Groundwater Application Review Summary Form

Application # G- 18757

To: Kristopher Byrd, Well Construction and Compliance Section Manager
From: Joel Jeffery, Well Construction Program Coordinator
Subject: Review of Water Right Application G-18757
Date: March 28, 2019

TO: Water Rights Section Date 3/22/2019
 FROM: Groundwater Section Benjamin Scandella, Jen Woody
Reviewer's Name
 SUBJECT: Application G-18757 Supersedes review of _____
Date of Review(s)

Figure 2: Well Location Map

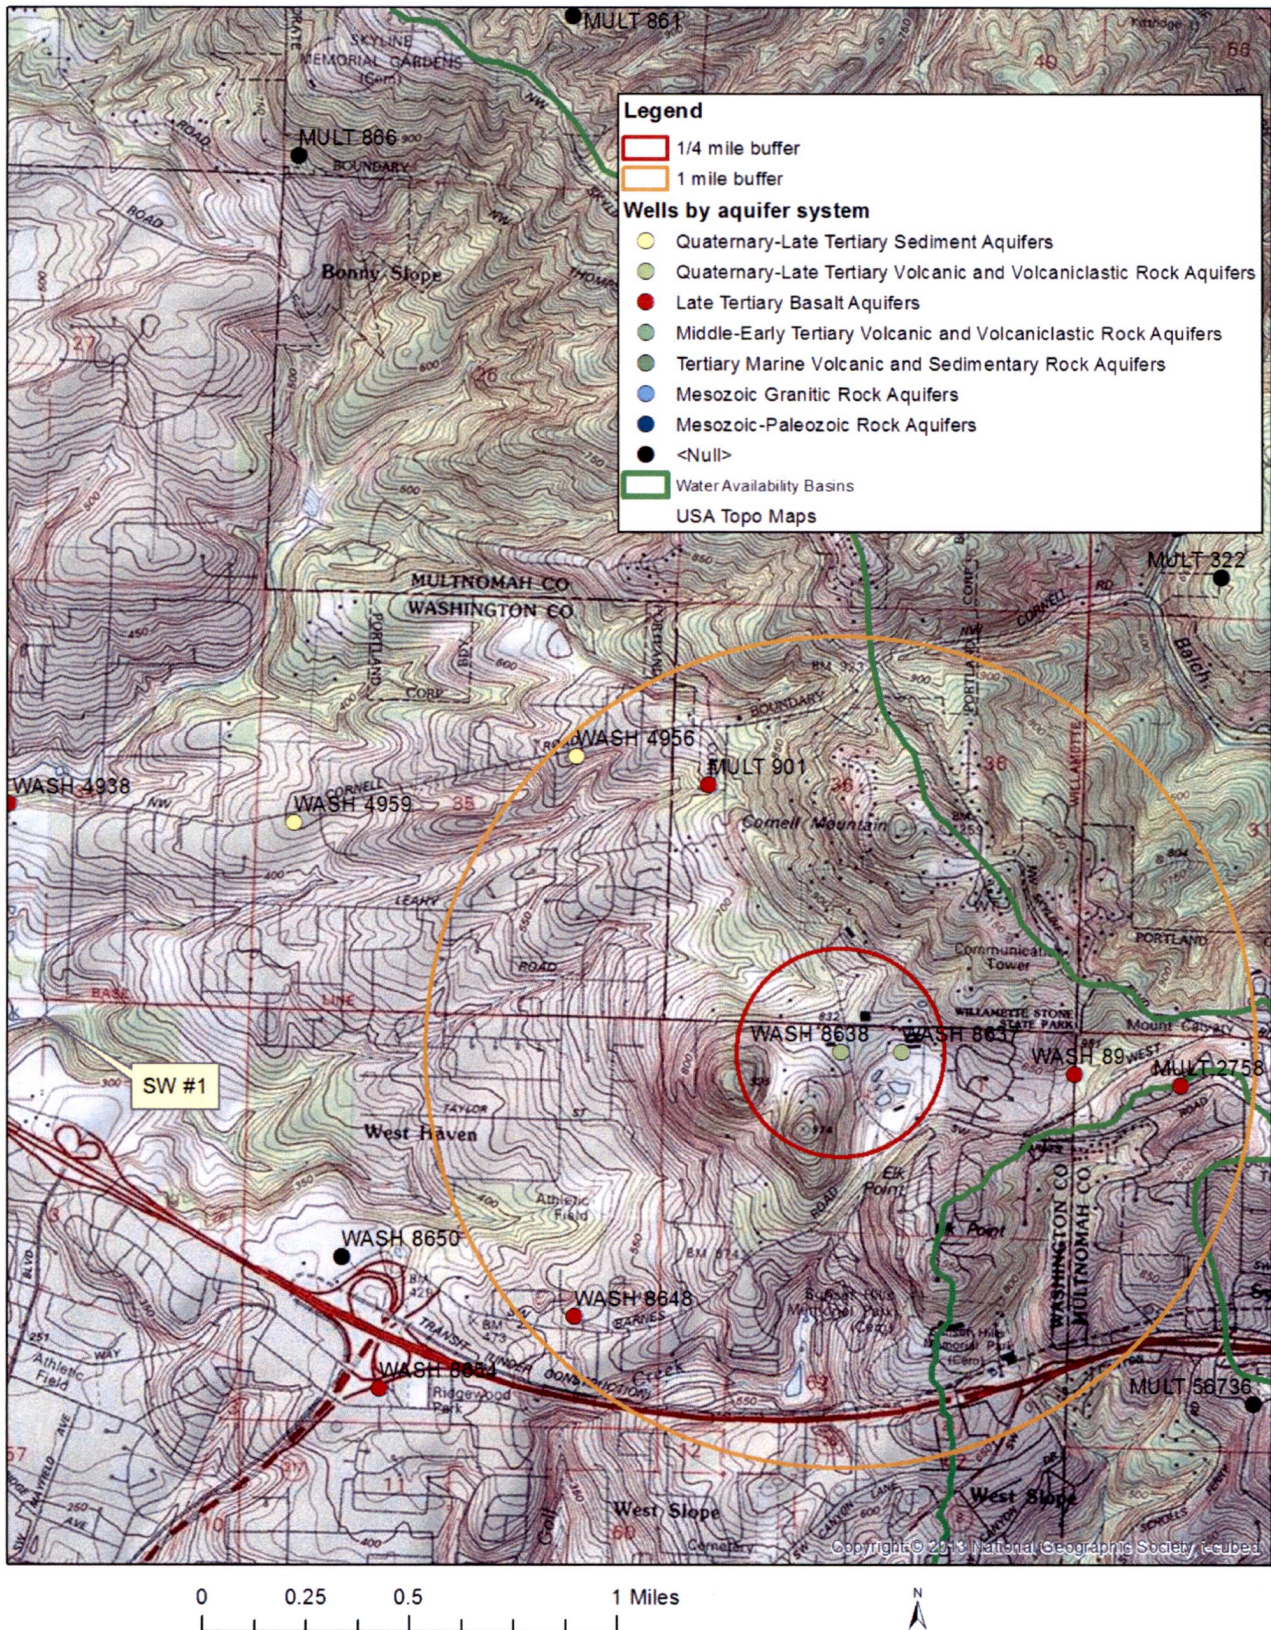
- A4. **Comments:** The applicant's well is located in the west foothills of the Tualatin mountains, about 1 mile northwest of Sylvan. The application suggests that the source aquifer would be "BEDROCK," but geologic analysis suggests that the well is completed into the Quaternary-Late Tertiary Volcanic and Volcaniclastic Aquifer System.

The applicant’s proposed well is located on the west slope of the Tualatin Mountains, which consist primarily of uplifted Columbia River Basalts. Overlying the basalts on the west slope are undifferentiated Valley Fill sediments and a discontinuous surficial layer of Boring Lava (Conlon, 2005; Hart and Newcomb, 1965; Woodward *et al.*, 1998). Each of these hydrogeologic units appear on nearby well logs, and mapped faulting in the region juxtaposes these hydrogeologic units and may provide vertical connectivity between them. This varied lithology suggests that the aquifer system accessed by the well is the Quaternary-Late Tertiary Volcanic and Volcaniclastic (QLTV) Aquifer System.

Figure 3: Hydrograph of Water Levels in Nearby Wells

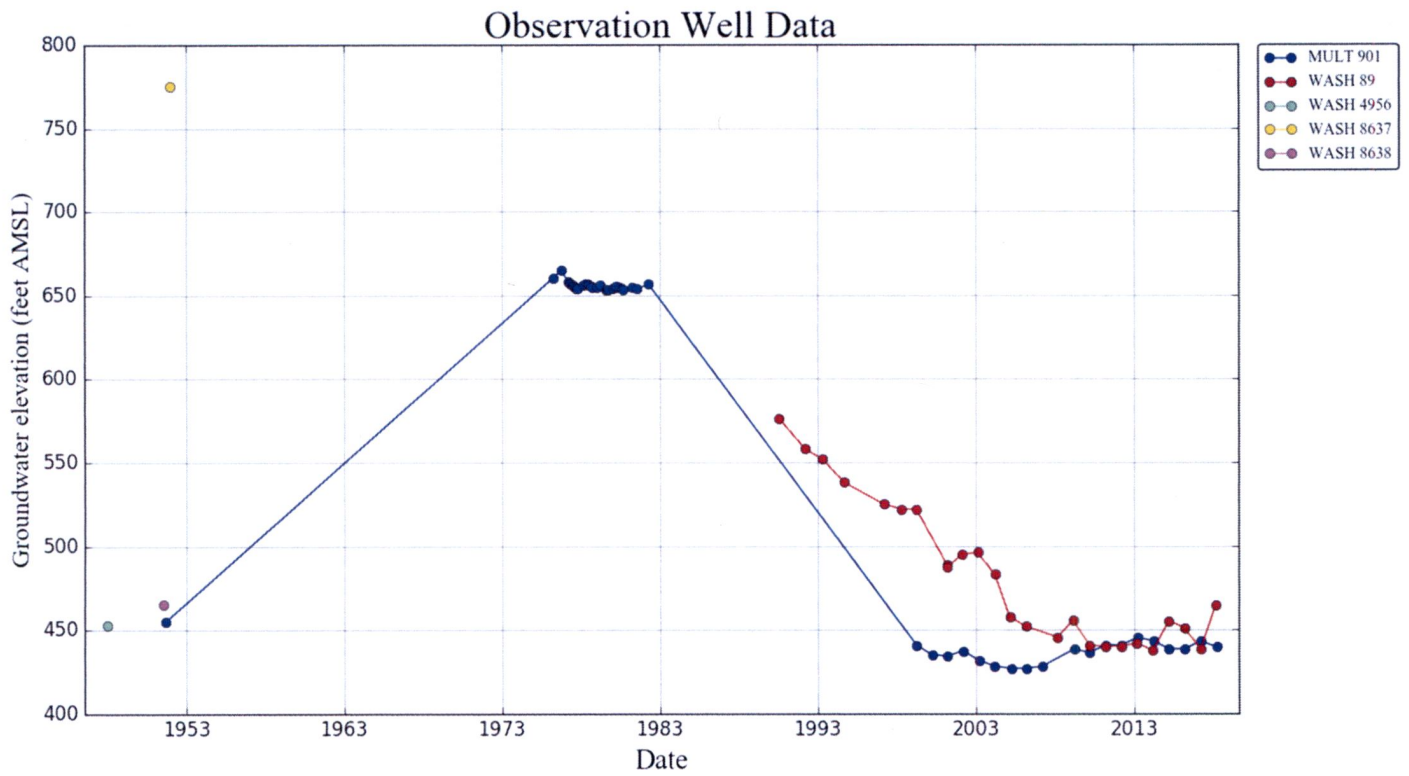
Water levels measured after drilling in the QLTV Aquifer System are not available in the vicinity of WASH 8638, but water levels in the CRB show more than 200 feet of declines between 1983 and 2010, as measured in nearby MULT 901 and WASH 89 (see map and hydrograph below). Although the declines appear to have abated recently, their large magnitude suggests that more water is not available within the capacity of the resource. In the event that a permit is issued despite this finding that water is not available, the permit conditions indicated in section B1di above should be included to monitor the resource and protect existing users.

- i. The permit should contain condition #(s) 7N (Annual Measurement), Large Water Use Reporting ;
 - ii. The permit should be conditioned as indicated in item 2 below.
